7.0 Transport

Revised planning application - Lower basement level -2 showing extent of structural constraint to increase core size

Revised planning application - Ground floor plan and cross section. Bike route shown in red.

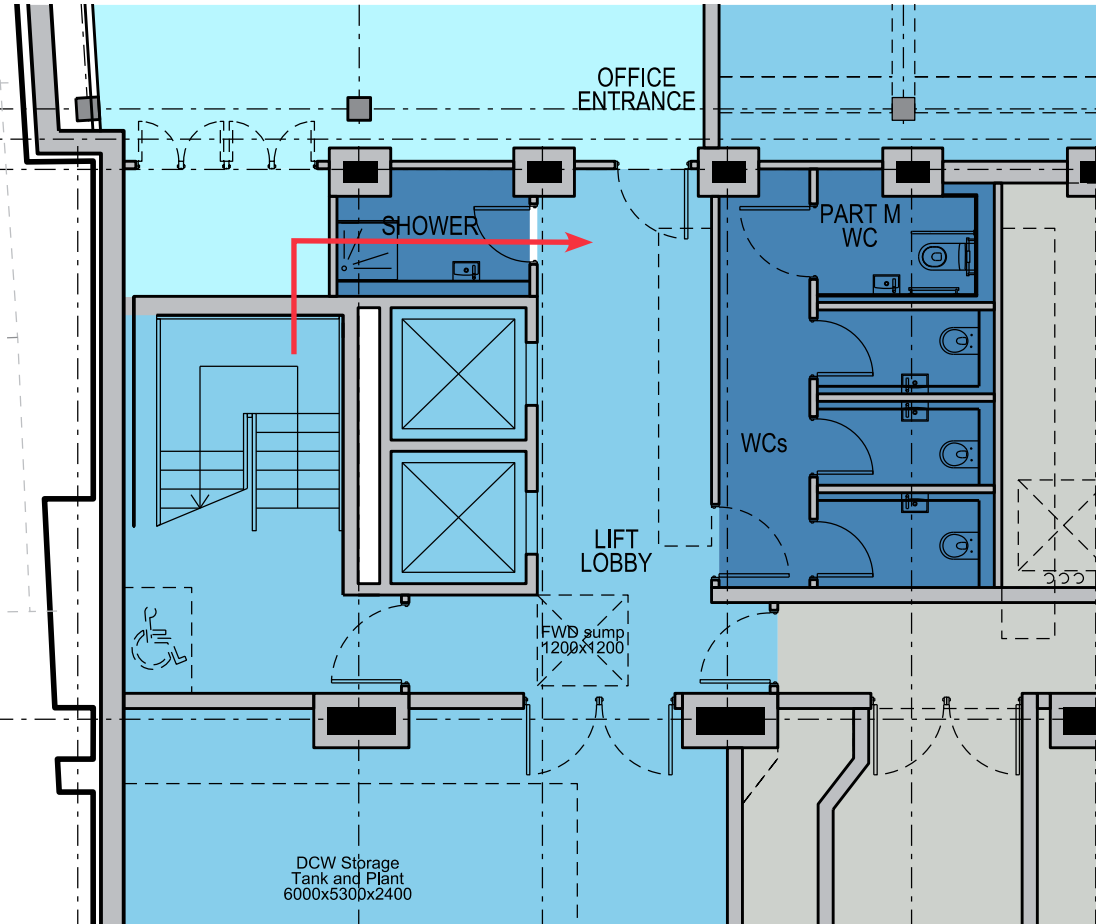
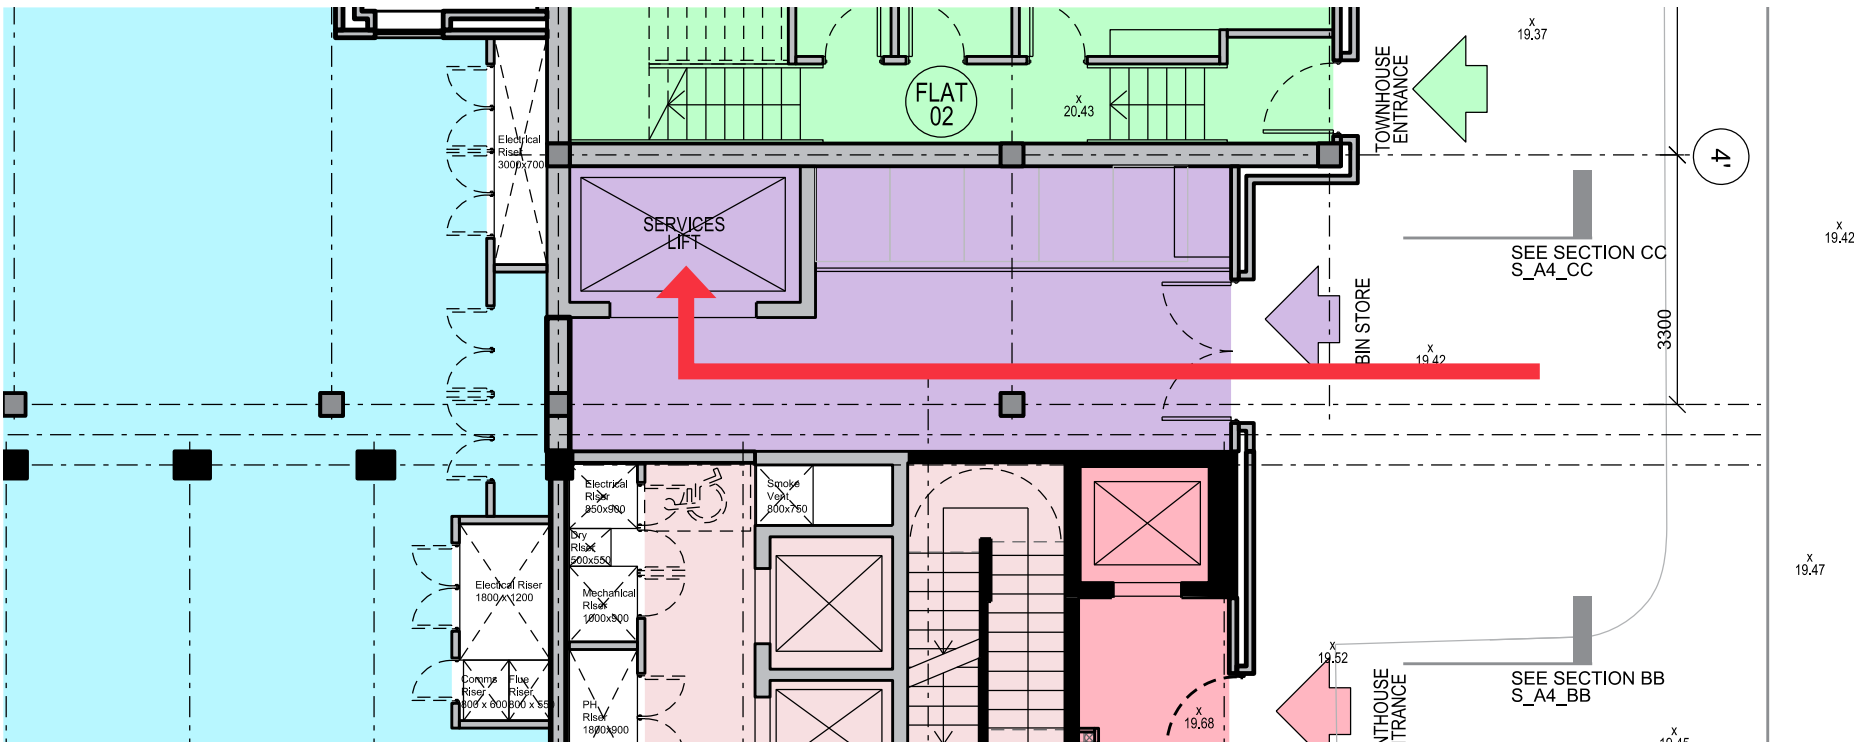
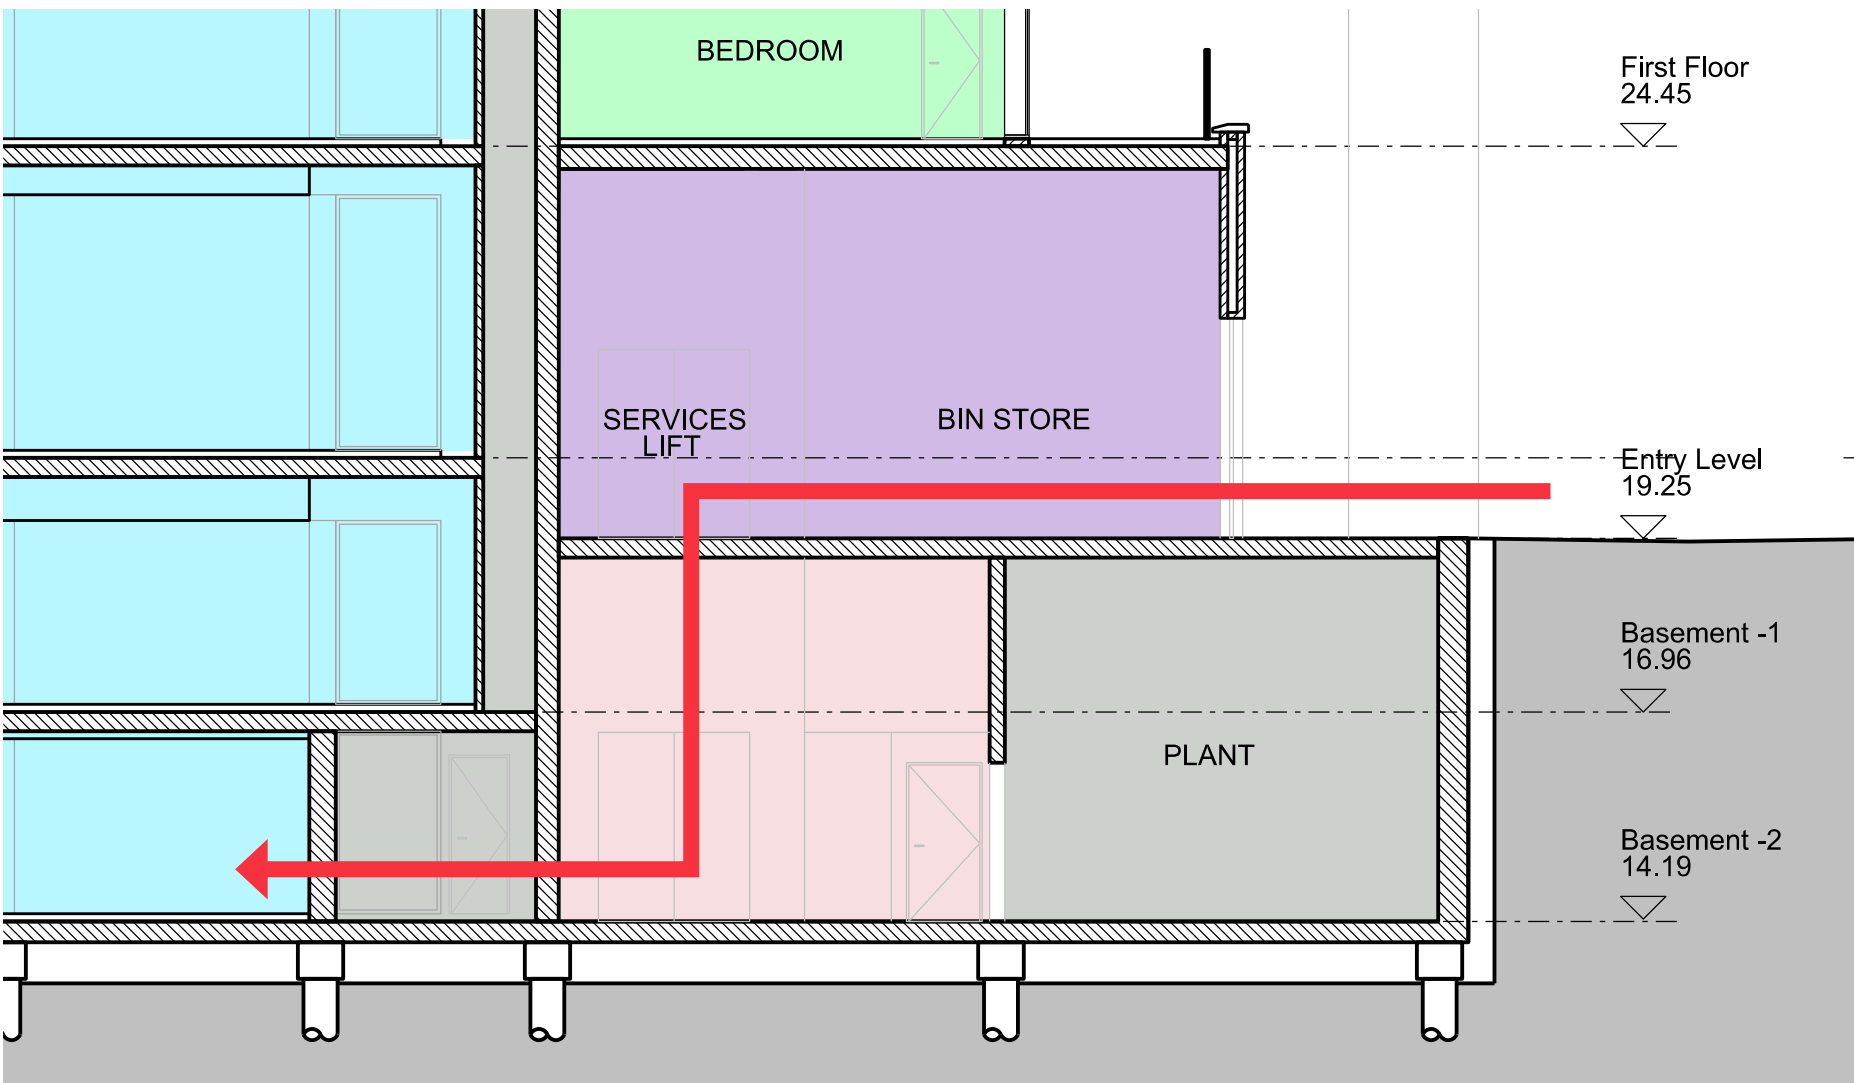
7.6 *Use of the service lift for cycle , as suggested in the TA, is not considered appropriate.*

7.3.2 It is proposed to use the main service door on Tottenham Mews to gain access to the bike store. This will be controlled by CCTV and key fob system to access the service door and the main service lift. This provides a direct route to and from the street. Adequate security measures will be provided and designed to Secure by Design standards. The bin store area on ground floor is only a temporary holding area for bins on designated collection days. The main bin stores will be located on the lower basement floors and moved to the temporary holding area on bin collection days. This will be managed so as to provide a clear and safe route for cyclists to use the lift and gain access to the bike stores. The service lift will provide adequate space for more than 1 bike to use the lift at the same time and will provide a quick and direct route to the bike storage area for residential and office cyclists.

7.6.1 Please refer to item 7.3. Due to the constraints of the existing building it is not feasible to provide 2 lifts with 1 lift large enough for bike movement. To incorporate a bike lift within the main office core area a third lift would have to be provided as 1 large lift and 1 small lift would not provide adequate space for passengers numbers and peak demands.

The use of the service lift is referred to in the TA as an additional option. Its use is not essential for access. Due to the relocation of the commercial bike store the use of the service lift would provide adequate space and a direct route to street level.

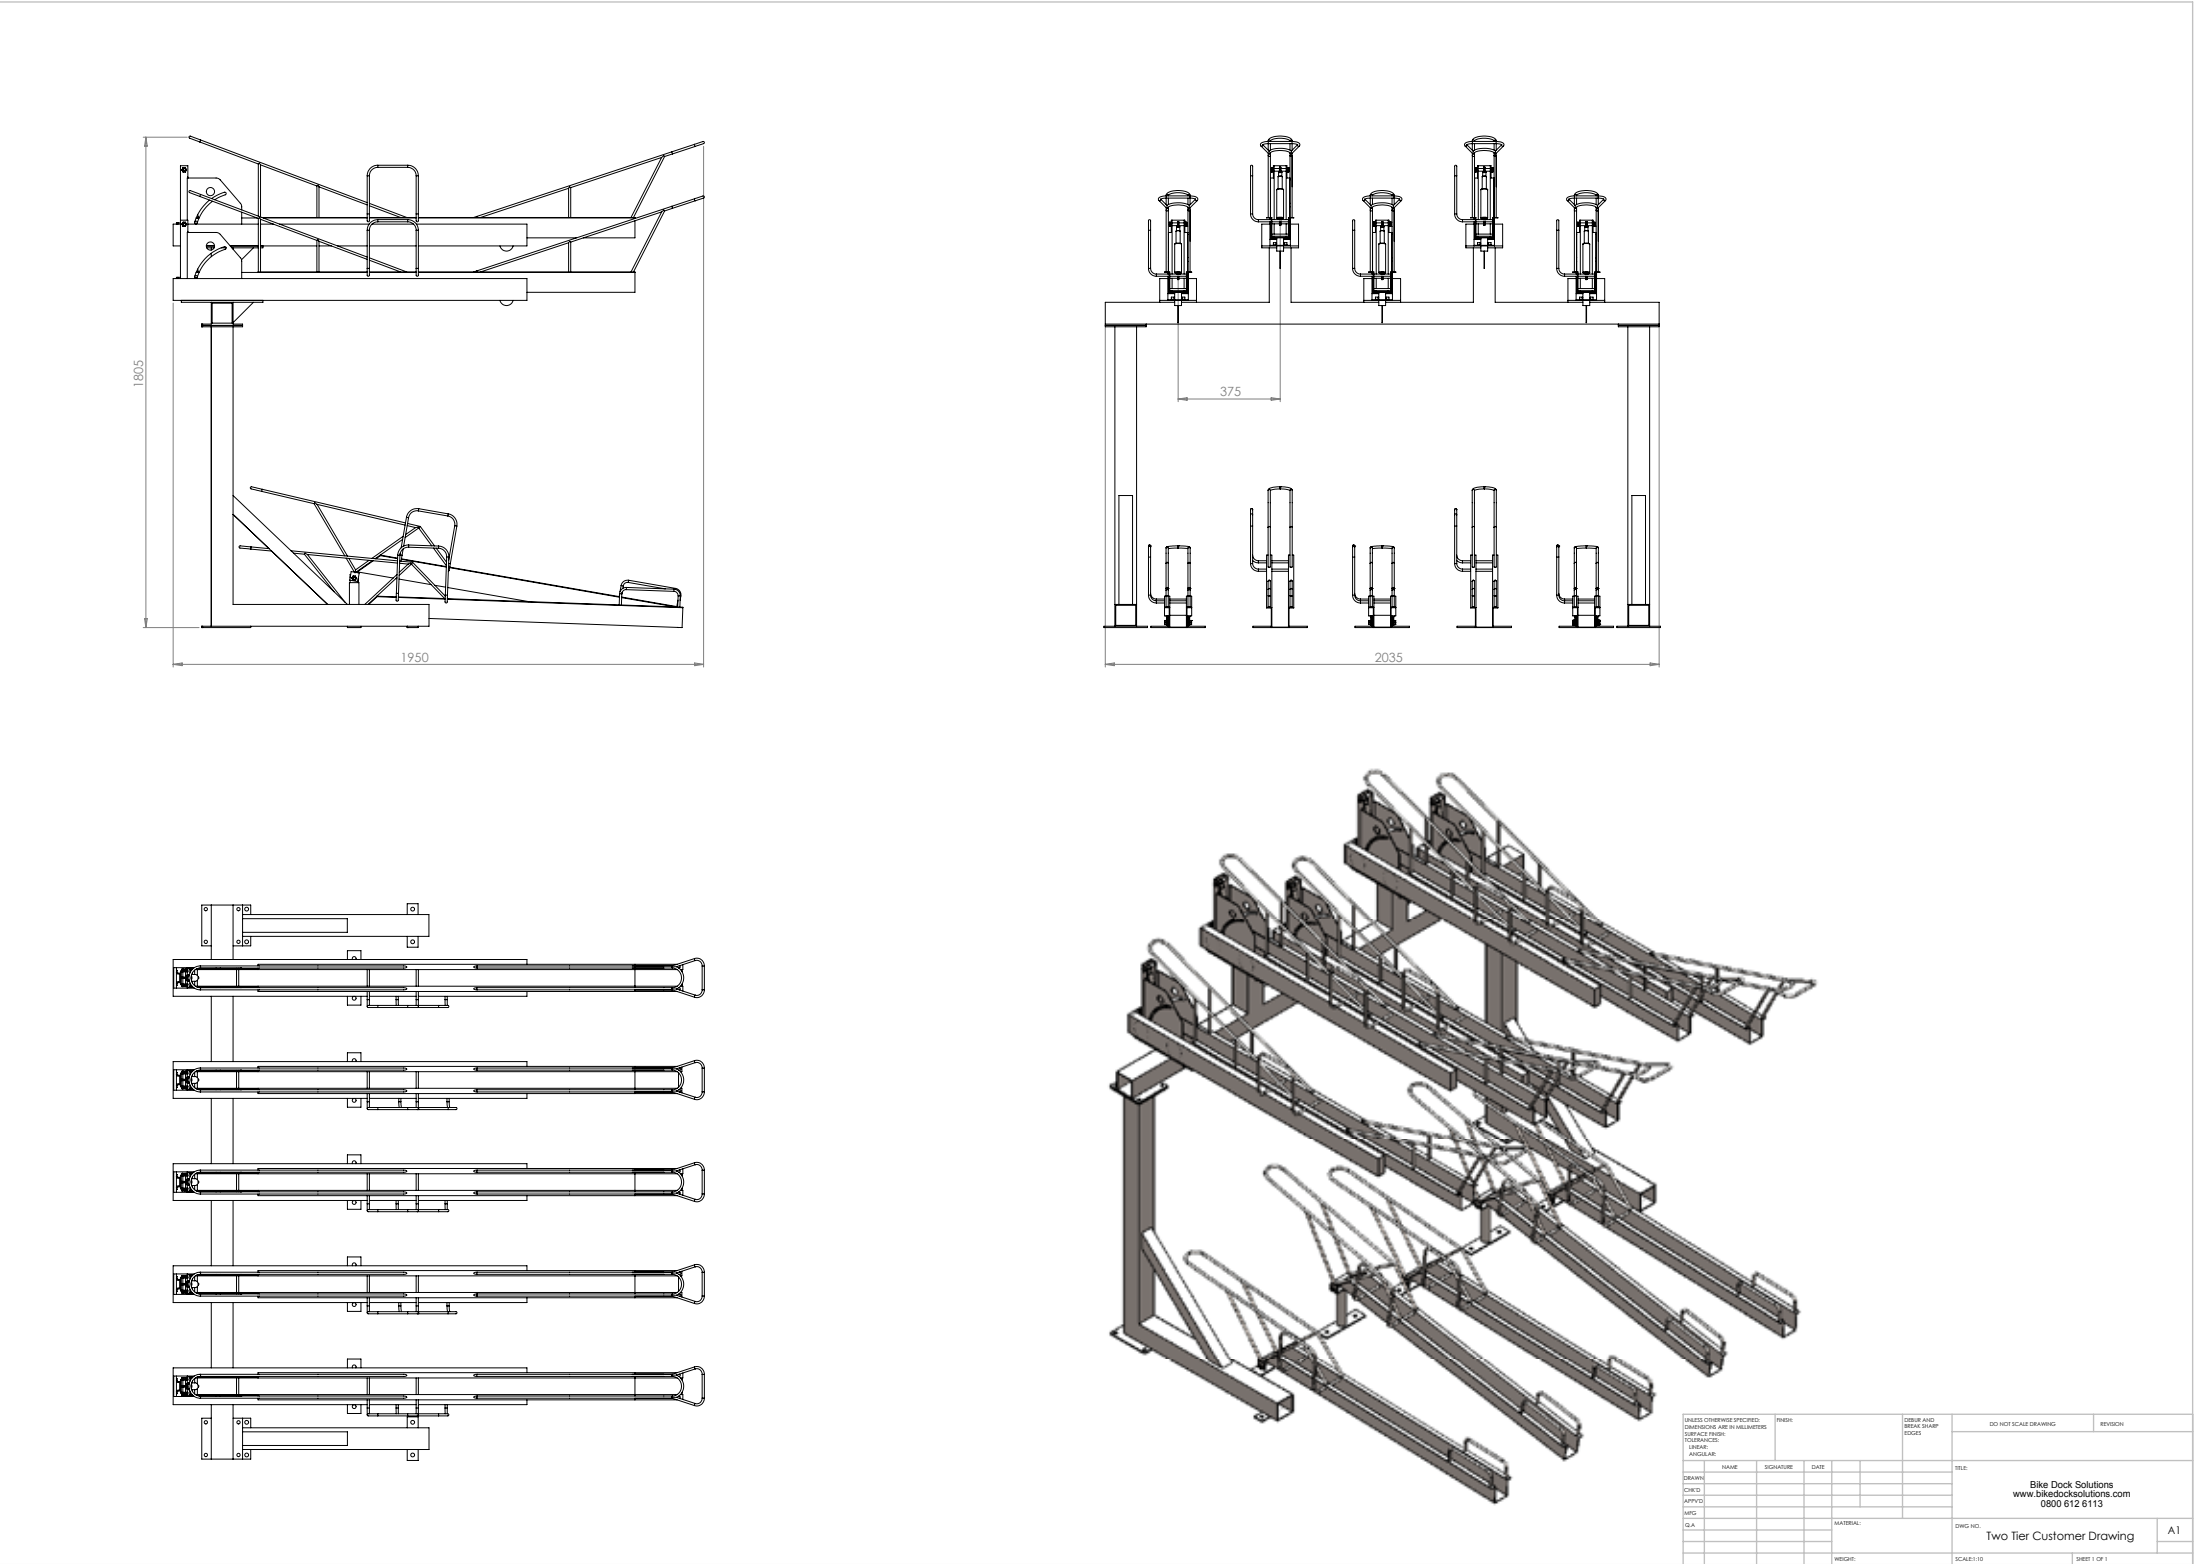
7.4 For josta stands a ceiling height of 2.5 meters is required. Can you please confirm that this ceiling height is achieved in the cycle store.

7.4.1 The residential bike store and the main majority of the commercial bike storage area will be located within the new build development. This will have a clear floor to ceiling height of 2.5m. The bike store located within the existing Arthur Stanley House structure will have a floor to ceiling height of 2.4m

A two tier bike racking systems can be accommodated within the 2.4 meter height. This has been confirmed by Bike dock solutions. See attached drawings.
